CITY OF SEATTLE
ANALYSIS AND RECOMMENDATION OF THE DIRECTOR OF THE DEPARTMENT OF PLANNING AND DEVELOPMENT

Application Number:	3014619
Council File Number:	CF # 312943
Applicant Name:	Kim Baldwin for Seattle Department of Parks and Recreation
Address of Proposal:	5513 South Cloverdale Street

RAINIER BEACH URBAN FARM AND WETLAND IMPROVEMENTS

2 A1.01 COMPOST SHED NORTH ELEVATION
SCALE: 1/4" = 1'-0"

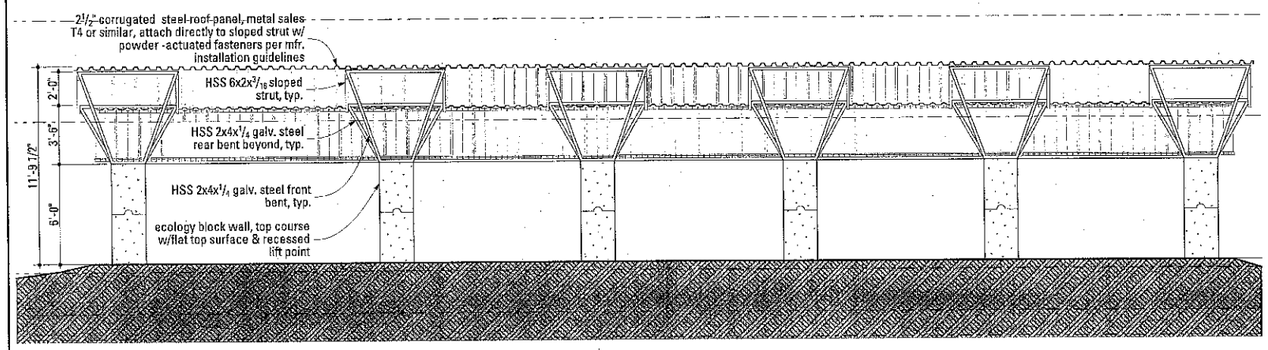
- Proposed Classroom Building: 21'
- Existing Greenhouse #2: 13'-5"
- Proposed Covered Compost Shed: 12'-10"
- Proposed Wash & Pack Building.: 19-2"

DPD recommends approval of the requested modification to development standards to allow the aforementioned four urban farm structures to exceed the 12' height limit.

5 A1.01 GREENHOUSE 2 TYP. END WALL ELEVATION
SCALE: 1/4" = 1'-0"

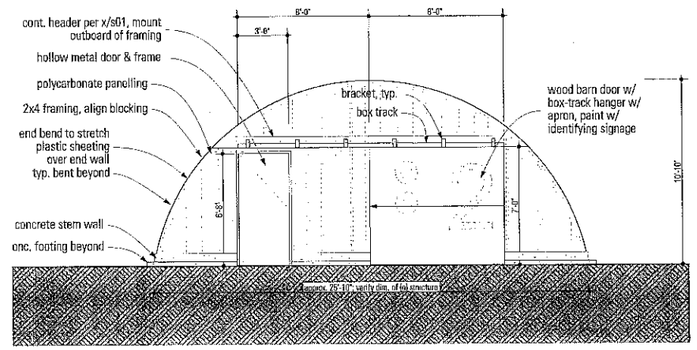
None of the aforementioned structures are situated in required yards (front, rear and sides) on the site. Greenhouse #2 is an existing structure that will remain in place. The submitted MUP plans illustrate the classroom building and wash/pack building having foundations and upper portions of each structure inset into existing sloping topography. These structures are located approximately 80' to the residential properties' nearest boundary lines to the east. The compost shed is centrally located on the project site and setback approximately 70' to the closest residential property boundary line to the west. PARKS's materials did not include special structural documentation justifying height requirements for the proposed structures.

1 A1.01 CLASSROOM EAST ELEVATION (PHASE 2)
SCALE: 3/16" = 1'-0"

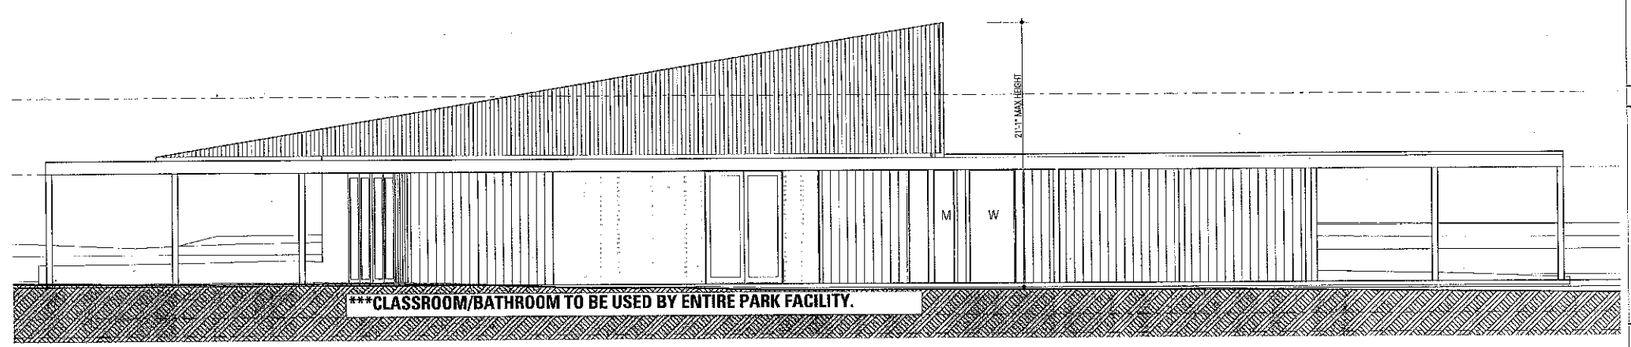
The Land Use Code requires structures for urban farm use to not exceed 12' in height, including any pitched roof. The Parks department is requesting a modification to development standards to allow the following structures to be constructed or allowed taller than the maximum urban farm structure height limit:

The height limitation of 12' is appropriate for urban farm structures accessory to a residential use. Conversely, the height limitation of 35' (meeting the pitched roof requirements) is appropriate for most structures in single family zones and is most consistent with the Comprehensive Plan when applied to public facility uses found in single family zones that achieve design compatibility with the scale and character of the surrounding area.

C. DPD recommends **approval** of the requested modification to development standards to allow four urban farm structures to exceed the 12' height limit. (21' maximum height proposed)
